Re: Responses to Third-Party Review and Town Comments; IWC App. WET#2918(S) Address: 64 Danbury Road, Wilton, Connecticut Applicants: Wilton – 64 Danbury Road Owner LLC (Owner) Fuller Development, LLC (Contract Purchaser)

As you know, our firm represents Wilton – 64 Danbury Road Owner LLC and Fuller Development, LLC (collectively, the "Applicants") in the above-referenced application (the "Application"), which proposes to redevelop the property located at 64 Danbury Road, in Wilton (the "Property") with multifamily housing. The Property is part of the larger parcel consisting of 50, 60, and 64 Danbury Road (the "Office Park"). Since the initial Application filing on January 2, 2024, the Applicants have received written feedback from the Wilton Public Works Department ("DPW"),¹ and the third-party reviewer for the proposal, Cardinal Engineering Associates ("Cardinal Engineering"), as well as questions and comments from you and the Inland Wetlands Commission (the "Commission"). The enclosed materials were prepared in response to these collective comments.

Sheet C-002 Existing Conditions Plan

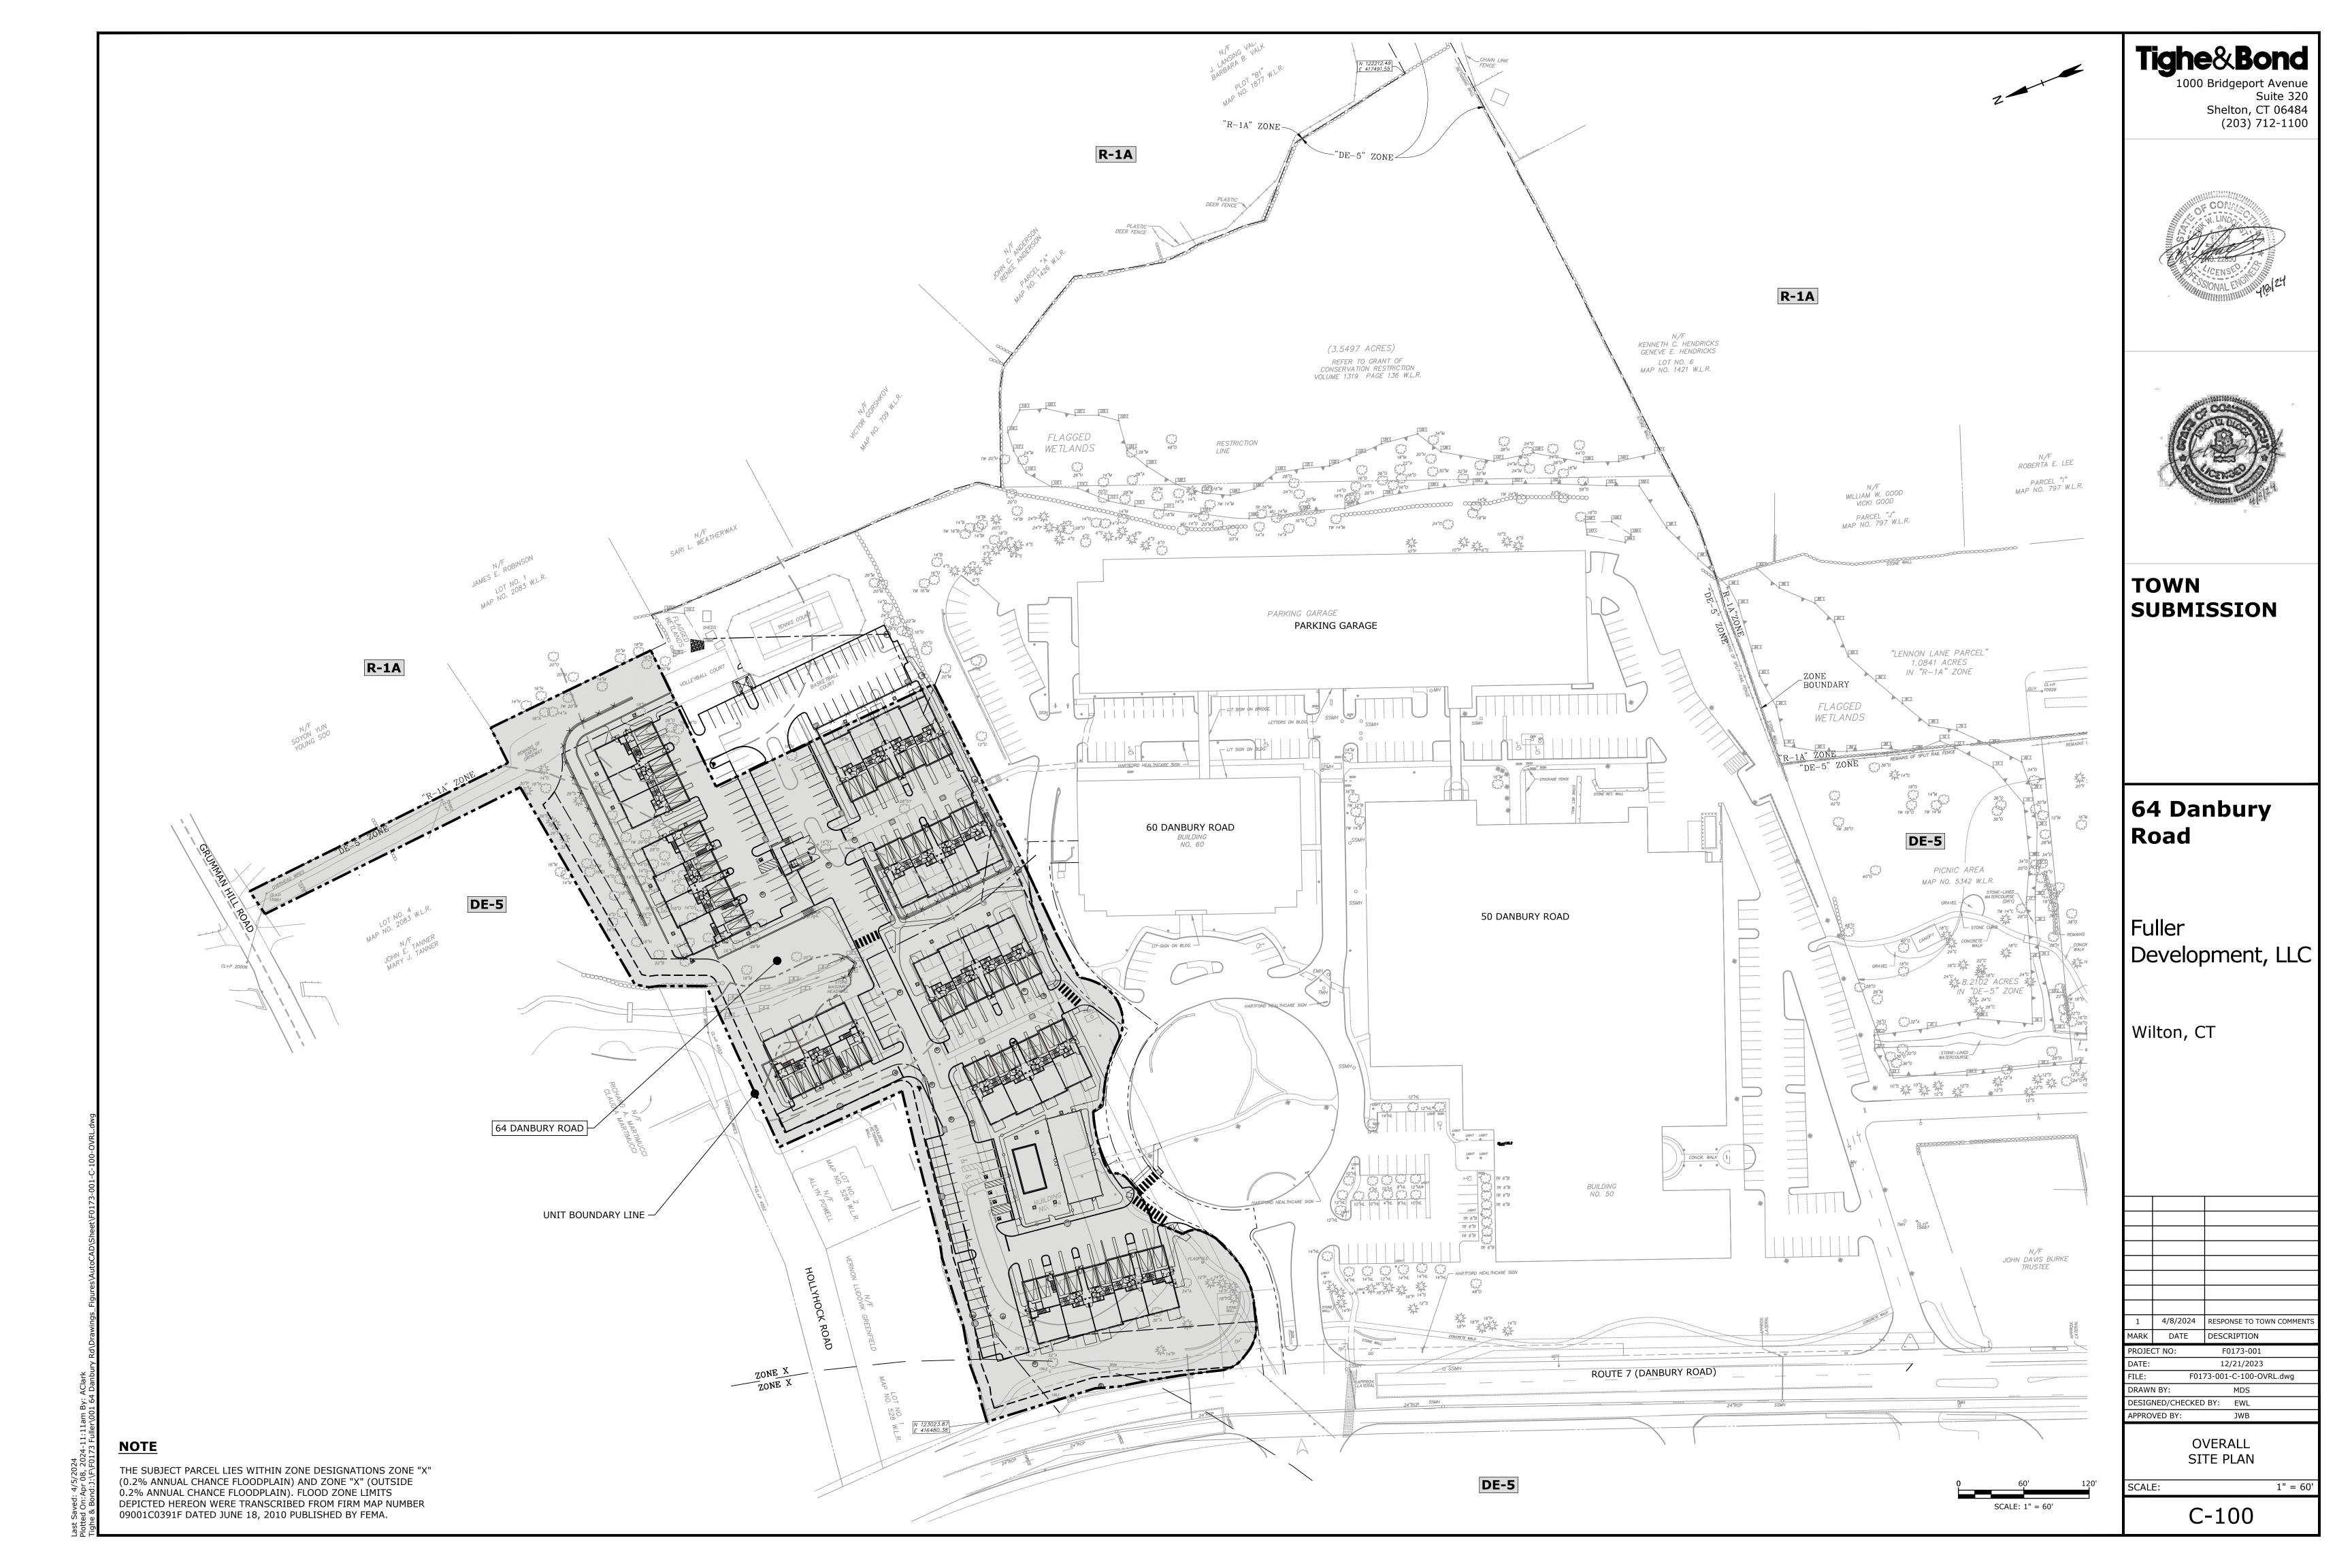
4. Prepare a demolition plan in order to more clearly show what utilities and features are being removed and what is proposed to be maintained, especially as it relates to the existing storm water infrastructure.

2. General-02: Due to the large number of existing utilities, it is strongly suggested to provide a utility demolition and preparation plan. Note utilities and storm drainage to be removed, to remain and protected, etc.

11. C-301-2: Provide a site demolition plan which includes how existing storm drainage flows are to be maintained where piping is proposed to be rerouted. Plan should also demolition of the existing building and associated utilities. Plan should also specify materials to be placed as backfill in the location of the foundation of the former building.

Response: The existing conditions plan has been updated to make note of the existing drainage pipes that are to remain and those to be removed/abandoned.

Response: Per discussions with the Town engineer, the existing conditions plan has been updated to include delineation of the existing storm drainage lines to remain and the ones to be removed.

Response: The existing conditions plan has been updated to document the existing storm drainage to remain and be abandoned/removed.

Sheet C-201 Grading Plan

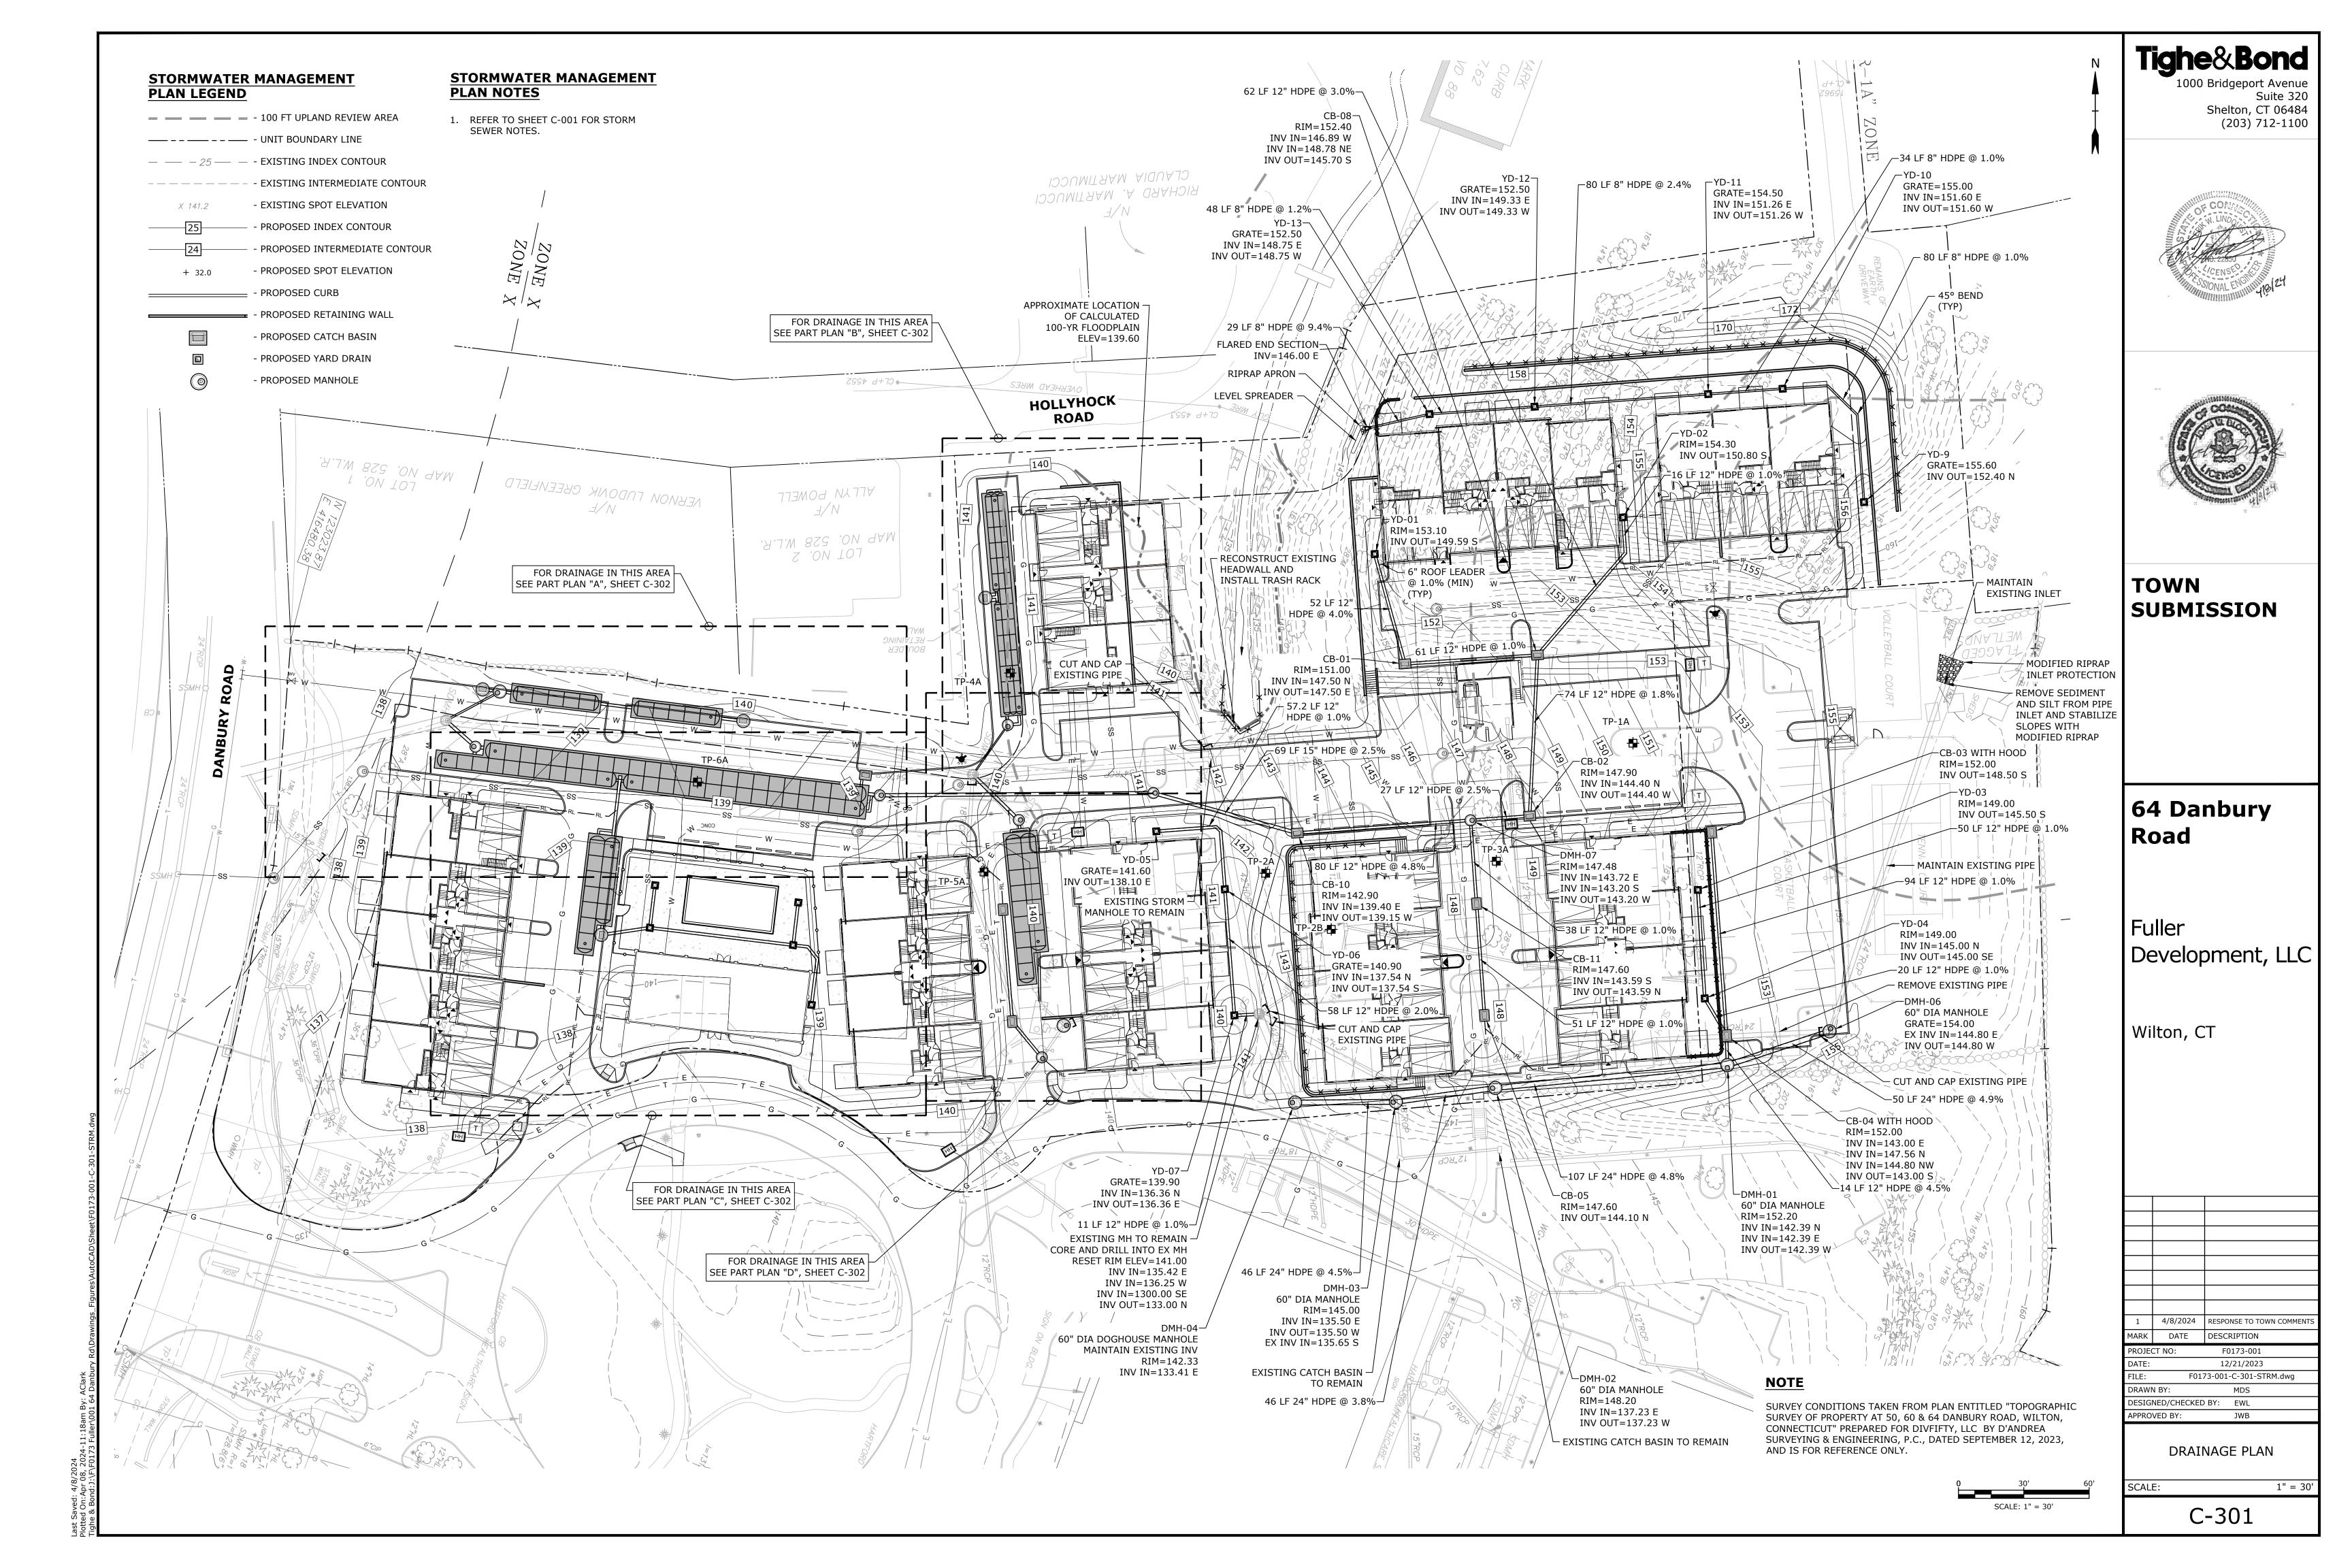
7. Add callouts to the plans for the top and bottom elevations of the proposed retaining walls.

8. C-201-1: Northeast corner of Building No. 4 is located within the limits of the 100year flood (El. 139.6). Fin. Flr. 141.7. The construction of the building results in a loss of flood storage capacity of the site. Provide compensatory storage volume. Area will be disturbed during construction. Provide proposed contours. Provide additional existing grades north and west of Building 4. Suggest providing TW and BW elevations of existing retaining wall on Lot 2 N/F Powell. Revise proposed contours north of north end of Building 4 parking area to reflect top of curb elevation of 141.50.

10. C-201-5: The plan calls for a significant amount of cut and removal of existing soil for the construction of Buildings 7 & 8 at the northeast corner of the site, which is within the 100-foot regulated area. This is an area of steep existing grades (>30%). The soil in this area is a Canton and Charlton complex which is a fine sandy loam and susceptible to erosion. Additional measures to protect the wetlands should be provided. Only a single row of silt fence with haybales is provided. The sediment trap is only proposed for the completion of the first phase of excavation.

Response: Top and bottom of wall elevations are shown on the grading plans.

Response: As noted in prior comments, the residential portion of the building is on columns and only a small area of the floodplain is being filled at the northern entry. Grading under the building has been slightly lowered to provide the required compensatory flood storage to account for this and the subsequent columns being added.

Response: The silt fence adjacent to the wetlands is not standard silt fence, it is heavy duty fencing with angled structural support and reinforced fabric. Another row was added to the erosion control plans during the initial phase to address these concerns.
